New treasury with upstair rooms for the Treasury Deputy Collector at Nellore

Revised estimate for constructing a — sanctioned

G.O. No. 1695 W., 8th June 1896.

New Treasury with upstair room for the Treasury Deputy Collector at Nellore

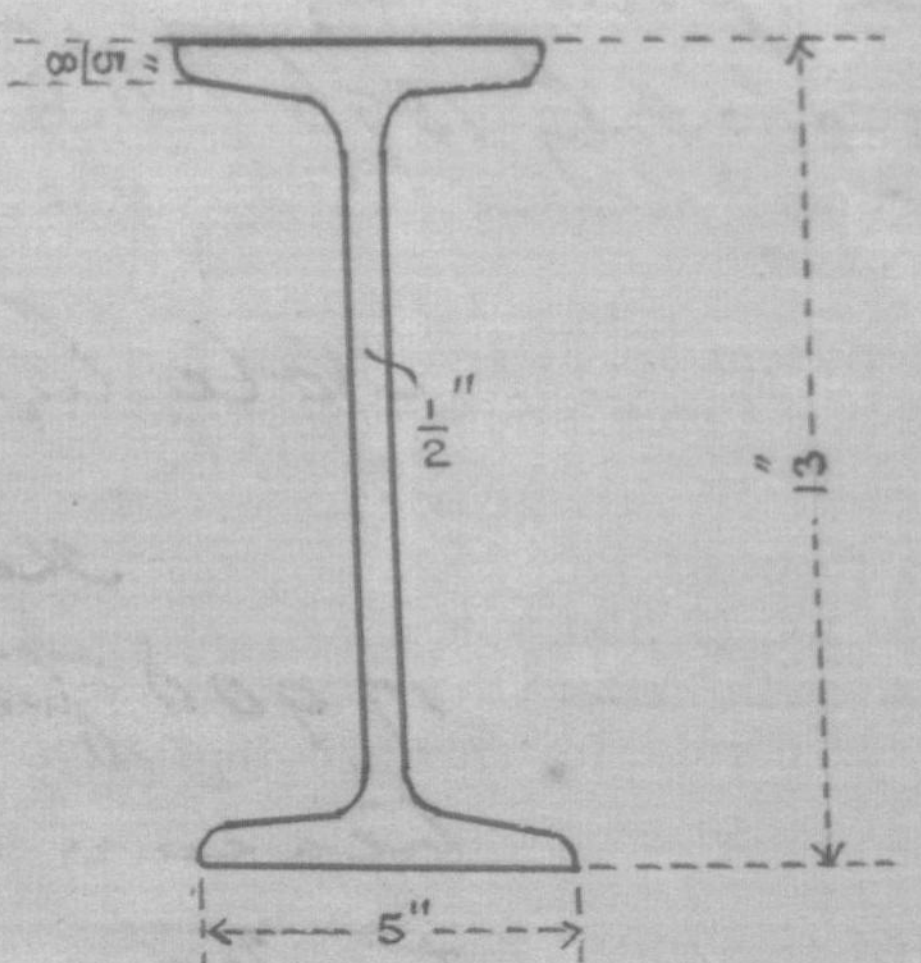
(*c*) It is proposed that the roof of the end verandah of the upper storey marked A in pencil on the plan should be supported on two masonry pillars 18 inches square, spaced 20·5 feet apart, carrying a wooden bressummer of a section 9″ × 17″. It would be preferable to put in a steel girder instead of a wooden bressummer. The weight to be carried (deadload) may be taken at 120 lb. per cubic foot of terracing

9" thick = 10 × 20·5 × $\frac{3}{4}$ = 154 cubic feet. 154 × 120 = 18,480 lb., of which the girder will carry half, *i.e.*, 9,240 lb. deadload, exclusive of parapet, which may be included as 120 lb. per cubic foot, allows a good margin. If a liveload of 120 lb. per square foot be added, an additional weight of 205 × 120 = 24,600 lb., or a total of $\frac{24,600 + 18,480}{2}$ = 21,540 lb. = 9·6 tons, will be obtained. For this, a steel girder of the section shown in the diagram below will do :—

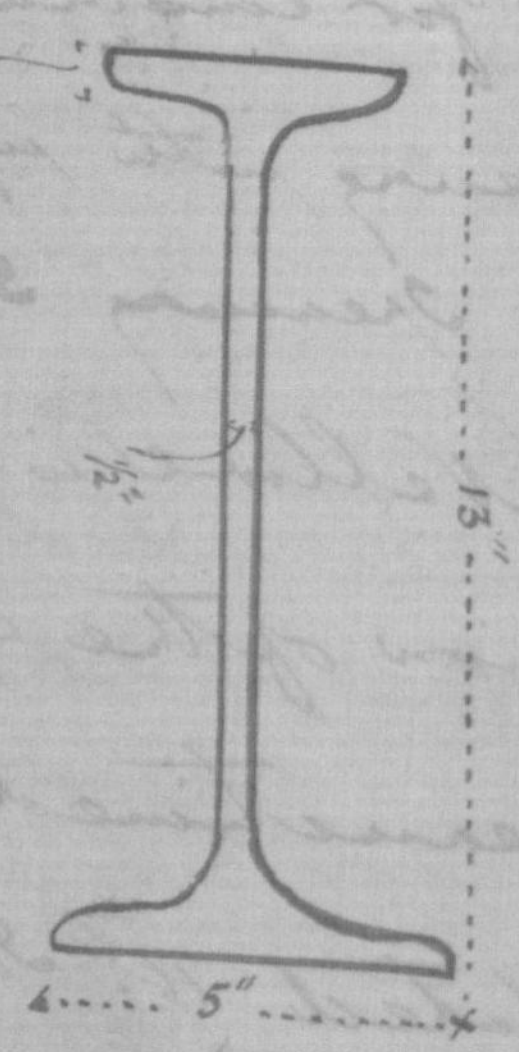
(c) It is proposed that the roof of the end verandah of the upper story marked A in pencil on the plan should be supported on two masonry pillars 18 inches square, spaced 20.5 feet apart, carrying a wooden bressummer of a section 9"×17". It would be preferable to put in a steel

girder instead of a wooden bressummer. The weight to be carried (dead load) may be taken at 120 lbs per cubic foot of terracing 9" thick = 10×20.5×3/4 = 154 c.f. 154×120 = 18480 lbs, of which the girder will carry half, i.e. 9240 lbs dead load, exclusive of parapet, which may be included as 120 lbs per cubic foot. allows a good margin If a live load of 120 lbs per square foot be added an additional weight of 20.5 × 120 = 24,600 lbs, or a total of $\frac{24.600 + 18,480}{2}$ = 21540 lbs = 9.6 tons will be obtained. For this, a steel girder of the section shewn in the diagram below will do:—

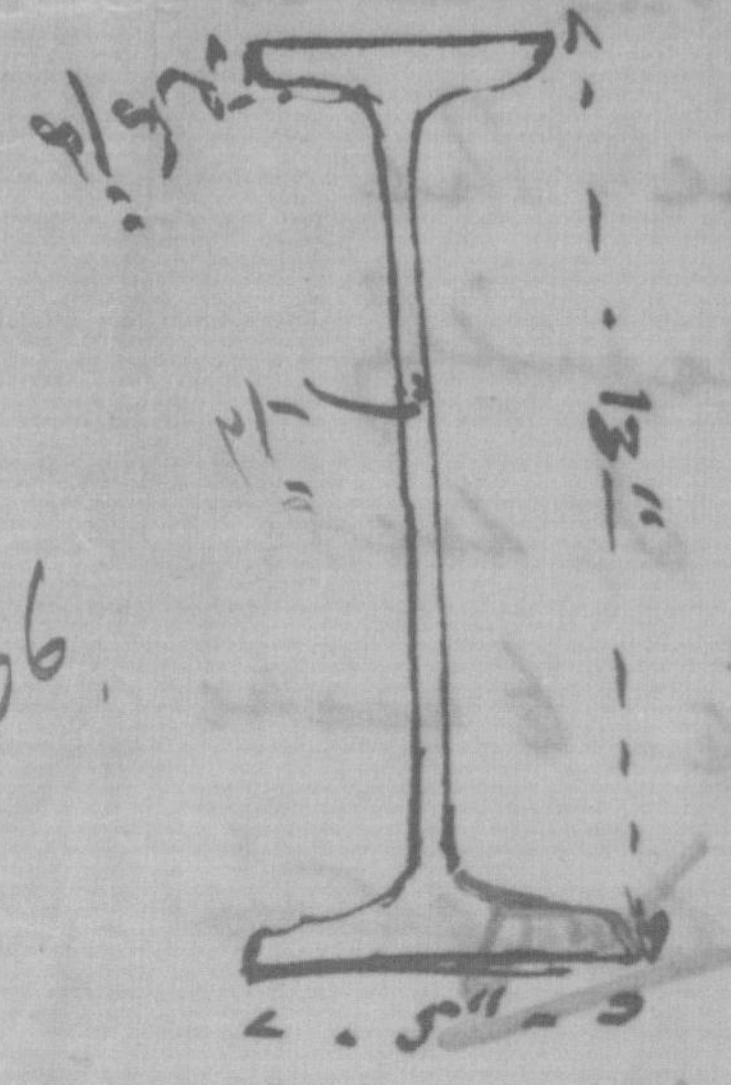
It would be preferable to provide a steel girder for the 20.5' span.

The weight to be carried (dead load) may be taken at 120 lbs per cubic feet of terrace 9" thick = 10 × 20.5 × $\frac{3}{4}$ = 154 c ft

154 × 120 lbs = 18480 lbs of which the girder will carry half = 9240 lbs dead load inclusive of parapet which may be included, as 120 lbs per cubic foot (allows a good margin). If a live-load of 120 lbs per sq: foot be added we get an additional weight of 205 × 120 = 24600

or total of $\frac{24600 + 18480}{2}$ = 21540 lbs

= 9.6 tons. For this a steel girder of the section shown in the annexed diagram will do (vide Dorman & Long's Catalogue - Plate 64)
